REGIONAL DISTRICT OF NANAIMO

Tender No. 23-057

Andover Road PRV Replacement

Addendum 2
Issued: September 21, 2023

ANDOVER ROAD
PLAN & PROFILE
0+000 - 0+240
FW-157A

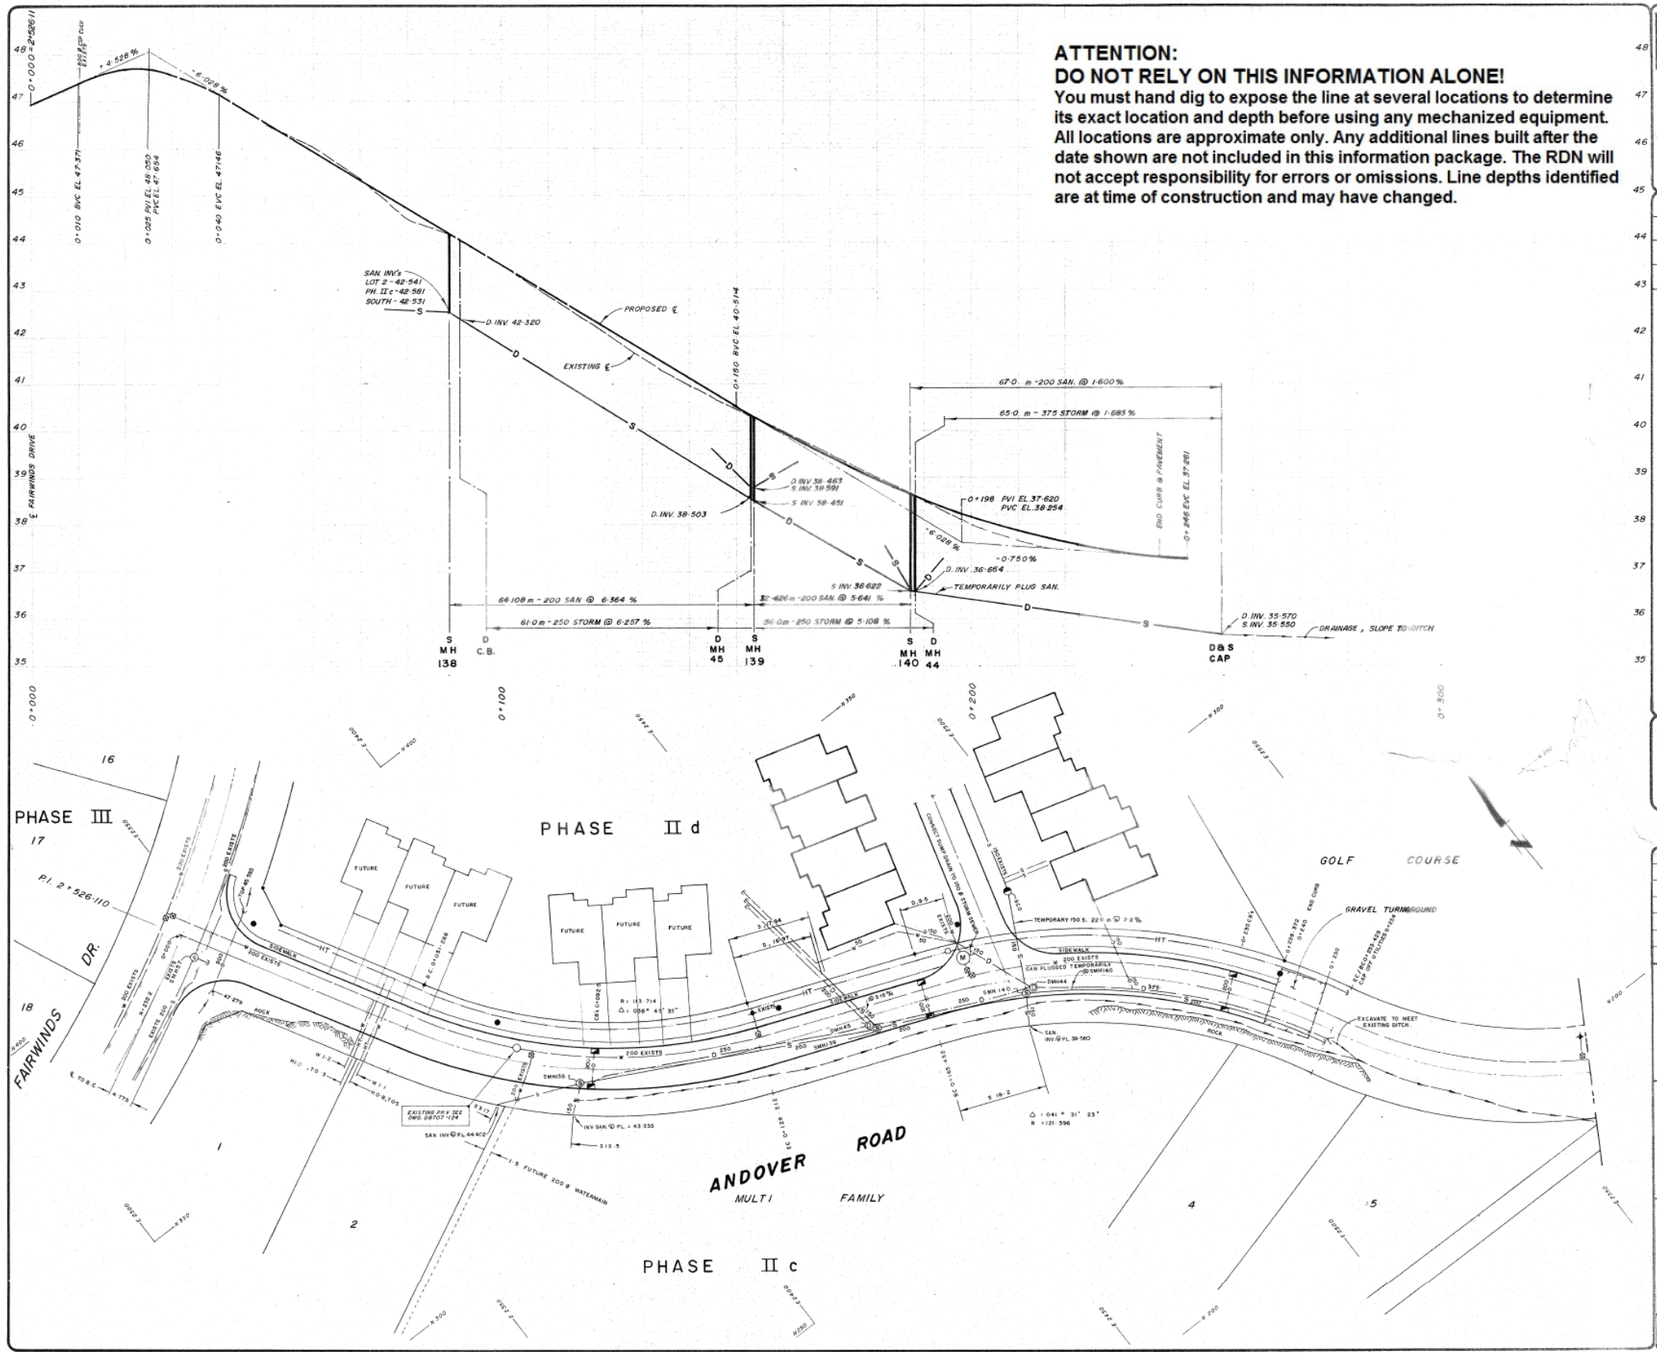
Question 2: Please provide a trenchline profile for the excavation to install the valve and piping in the roadway and boulevard?
Answer 2: Available as-builts showing the existing watermain profile is attached to this addendum. Please note that existing as-built drawings have been found to be inaccurate in the past. Therefore, RDN cannot guarantee the accuracy of these as-built drawings.
